# Team Update 05

# Team Update 01

## SECTION 5.7 CARGO

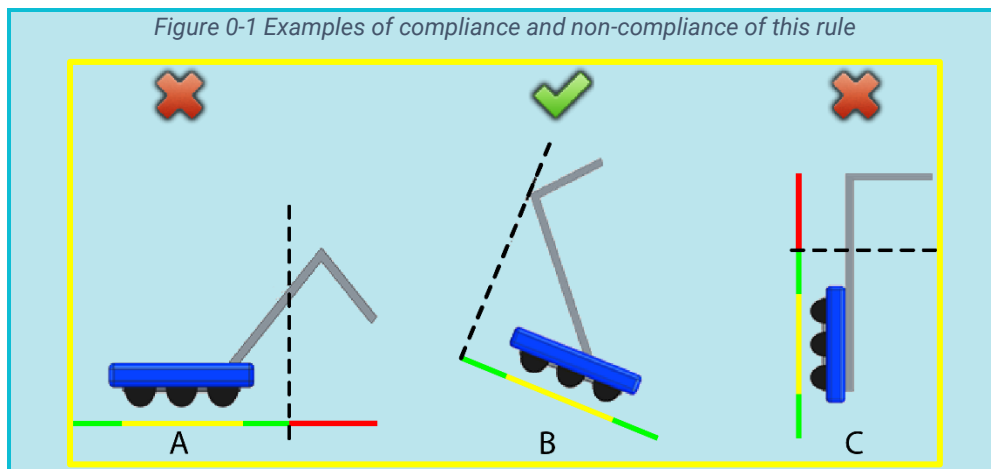
CARGO is inflated to 3½ psi. (checked using [this gauge](#) at official events).

Figure 6-1 MATCH setup

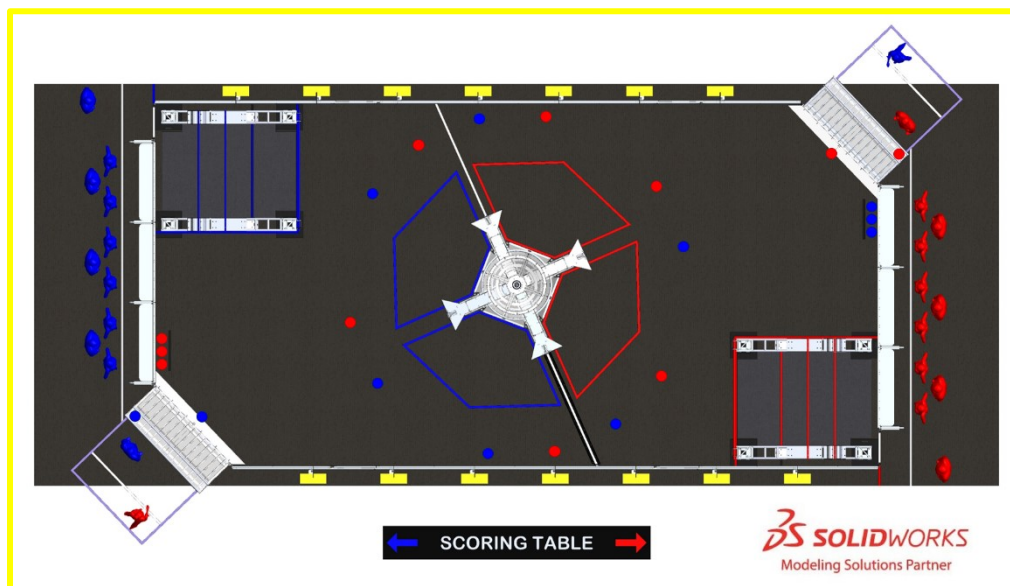
Figure 6-1 is updated to correct the starting location for CARGO not staged in ROBOTS.
